METROPOLITAN GOVERNMENT OF NASHVILLE AND DAVIDSON COUNTY

STAFF RECOMMENDATION
2403 Fairfax Avenue
October 17, 2012

Application: New construction - infill
District: Hillsboro-West End Neighborhood Conservation Zoning Overlay
Council District: 18
Map and Parcel Number: 10411017000
Applicant: Michael Ward, Allard Ward Architects, LLC
Project Lead: Robin Zeigler, Robin.Zeigler@nashville.gov

Roof Plan

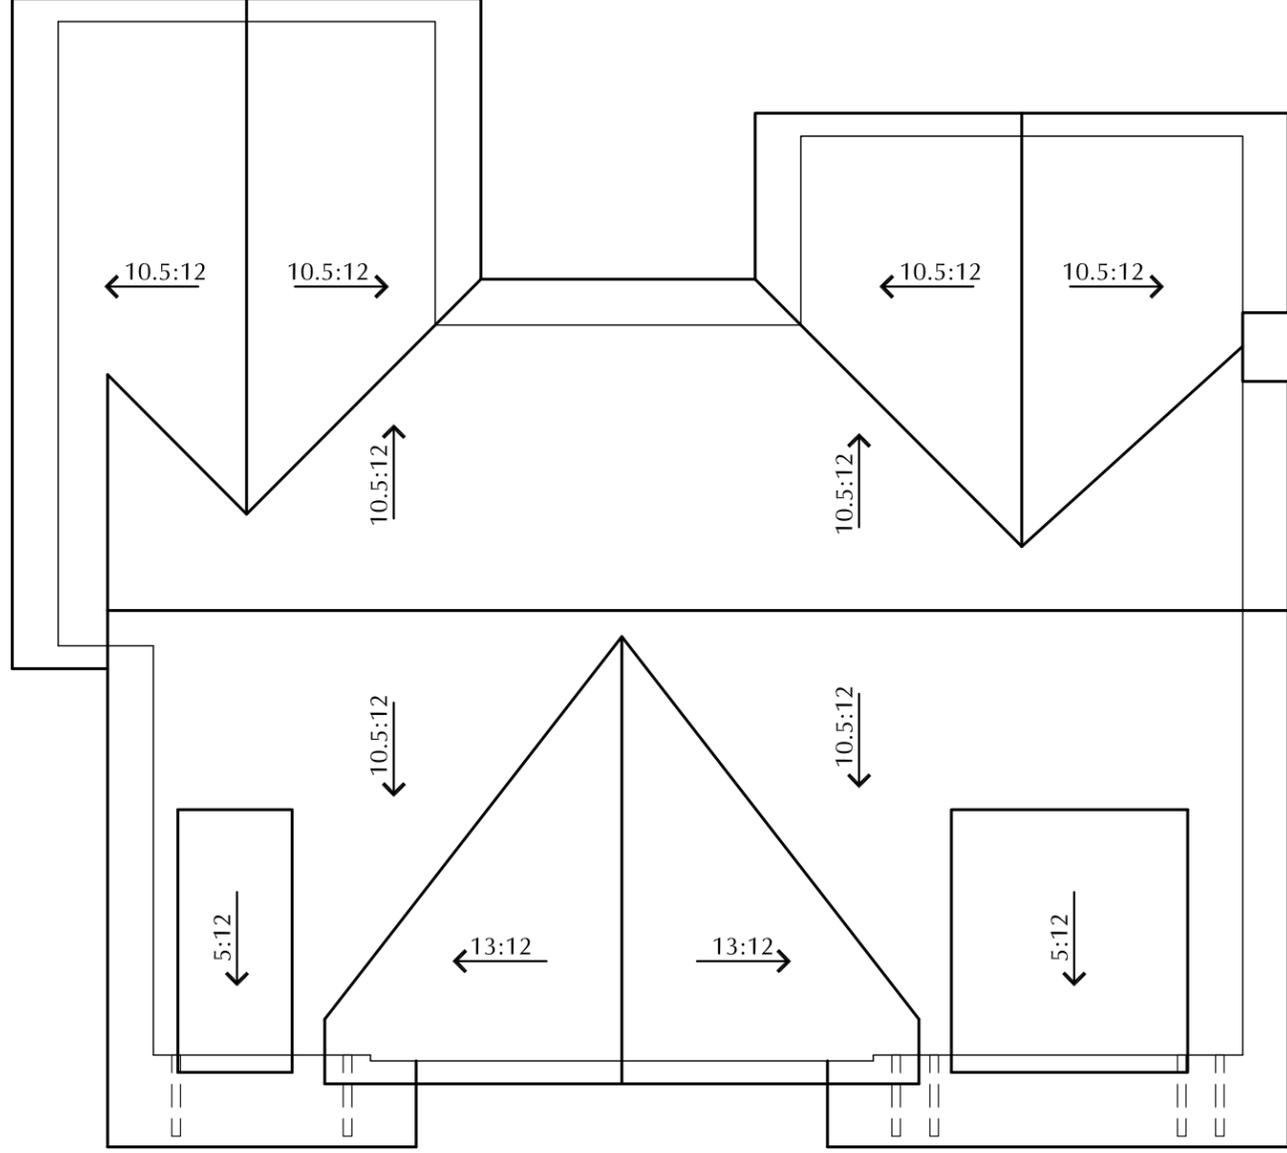
Roof Shape: The roof shape is a cross-gable with a primary pitch of 12/13. The roof dormers are an appropriate scale; however, the majority of historic roof dormers are set off the front wall a minimum of two feet (2’) and this one is approximately six inches (6”) off the wall. Staff recommends that the front dormers be set off the wall by two feet (2’). With this condition, the project meets section II.B.e of the design guidelines.

Staff recommends approval with the condition that staff provide final review of windows, doors, brick, location of HVAC, and roof color and that the front dormers sit off the wall by two feet (2'). Staff finds that the project meets section II.B. of the design guidelines for new construction in the Hillsboro-West End Neighborhood Conservation Zoning Overlay.
